The Commission has issued the enclosed Amendment No. 27 to Facility Operating License No. DPR-67 for St. Lucie Plant, Unit No. 1. The amendment consists of changes to the license and its appended Technical Specifications in accordance with your requests dated March 3 and 22, April 4, 5, 12 and 28, and May 1, 1978. Your applications were supplemented by information dated April 17 and 21, and May 11, 19, 22, and 23, 1978.

- (1) Technical Specification (TS) changes resulting from the analyses of Cycle 2 reload fuel;
- (2) TS changes to include consideration of a new water hole peaking factor;
- (3) Approval to operate with sleeved Control Element Assembly (CEA) guide tubes;
- (4) Deletion of certain license requirements that have been completed;
- (5) TS changes authorizing the removal of all part length control element assemblies;
- (6) Resistance Temperature Detector testing requirements; and
- (7) Extension of time to install neutron shielding.

ST. LUCIE PLANT UNIT NO. 1

Figure 2.2-2 LOCAL POWER DENSITY – HIGH TRIP SETPOINT
PART 2 (OR₂ VERSUS Y₁)

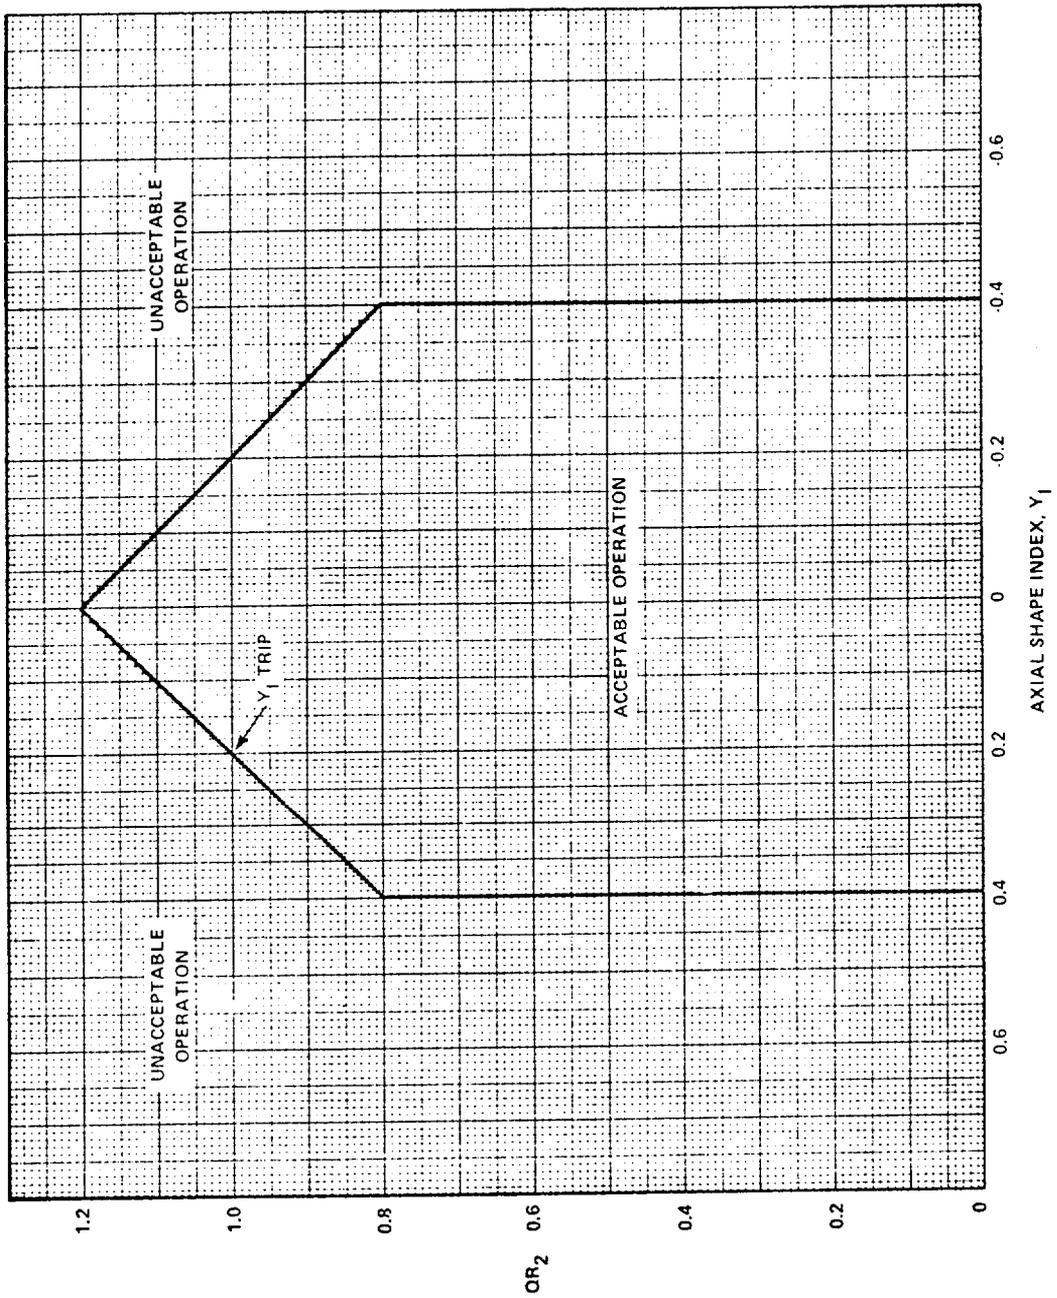
- (1) KW/FT LSSS (Local Power Density Trip - ASI Tent). The 10.4% uncertainty is assumed in the generation of the Local Overpower ASI Trip Tent of Technical Specification Figure 2.2-2.
- (2) KW/FT LCO - Continuous Incore Monitor. The 5.8% uncertainty is incorporated in the uncertainty parameter 1.058 of TS 4.2.1.4.b.2, and the remaining 4.6% is applied in the CECQR computer code which reduces the incore detector data.
- (3) KW/FT LCO - Continuous Excore Monitor. The 10.4% uncertainty is assumed in the generation of TS figures 3.2-3 and 3.2-4.

FIGURE 2.2-3
Thermal Margin/Low Pressure Trip Setpoint
Part 1 (Y_1 Versus A_1)

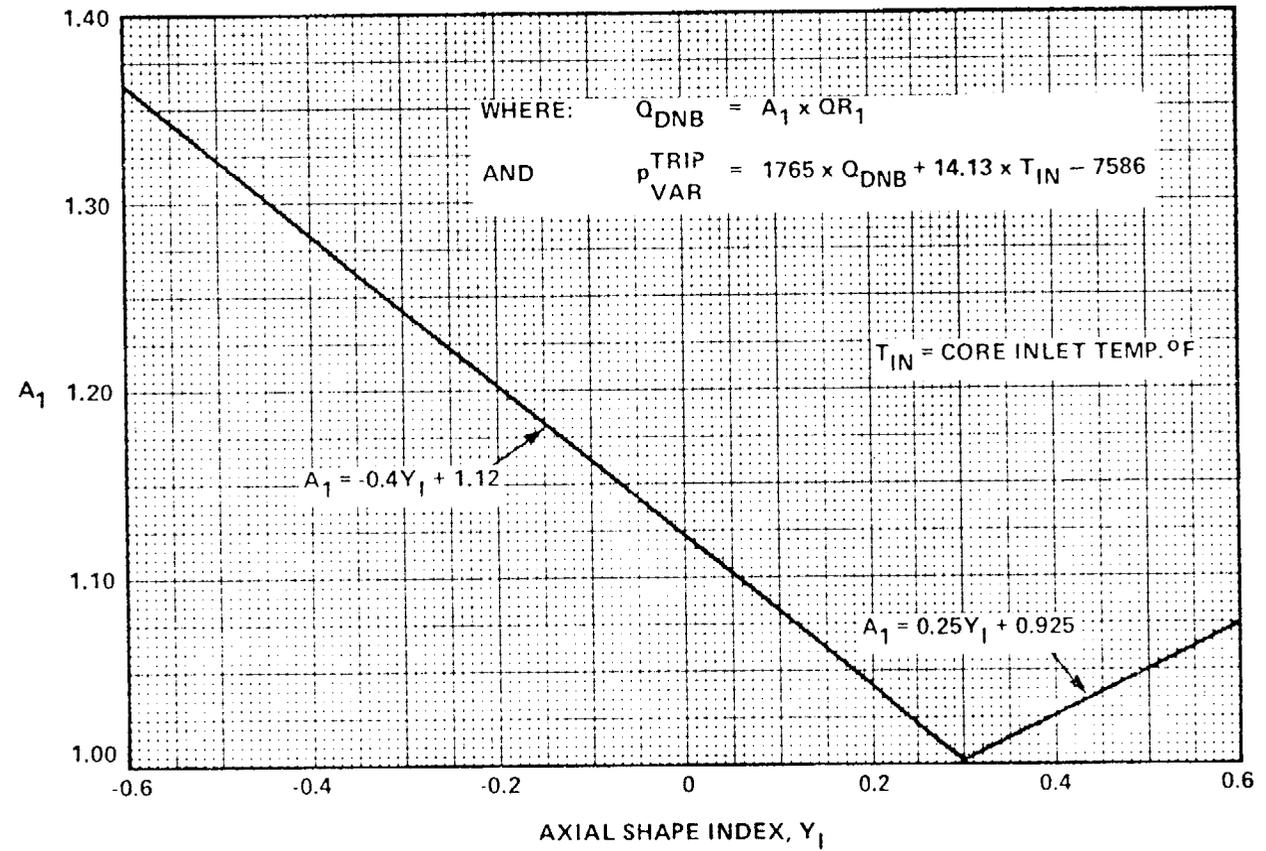
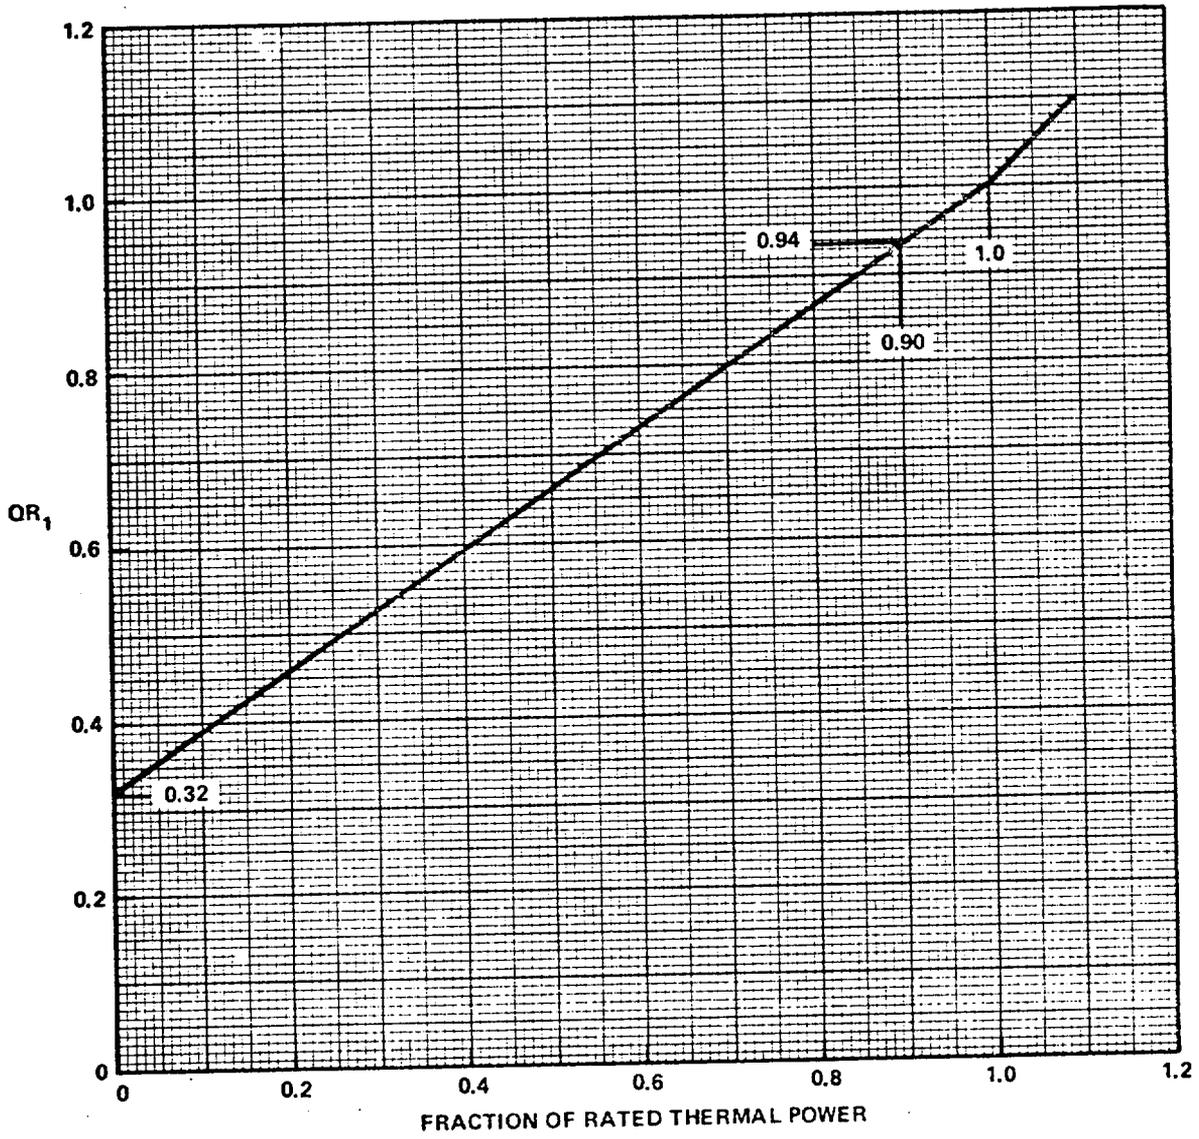
<u>FUNCTIONAL UNIT</u>	<u>TRIP SETPOINT</u>	<u>ALLOWABLE VALUES</u>
9. Thermal Margin/Low Pressure (1) Four Reactor Coolant Pumps Operating	Trip setpoint adjusted to not exceed the limit lines of Figures 2.2-3 and 2.2-4.	Trip setpoint adjusted to not exceed the limit lines of Figures 2.2-3 and 2.2-4.
10. Loss of Turbine -- Hydraulic Fluid Pressure - Low (3)	≥ 800 psig	≥ 800 psig
11. Rate of Change of Power - High (4)	≤ 2.49 decades per minute	≤ 2.49 decades per minute

The change in RTD response time from five to eight seconds resulted in a recomputation of the Thermal Margin - Lower Pressure (TM-LP) trip setpoint, γ , and the Delta-T power calculator setpoints (a, T) which have inputs from RTD. Both of these computations have been performed and the TS and Reactor Protection System (RPS) values adjusted accordingly.
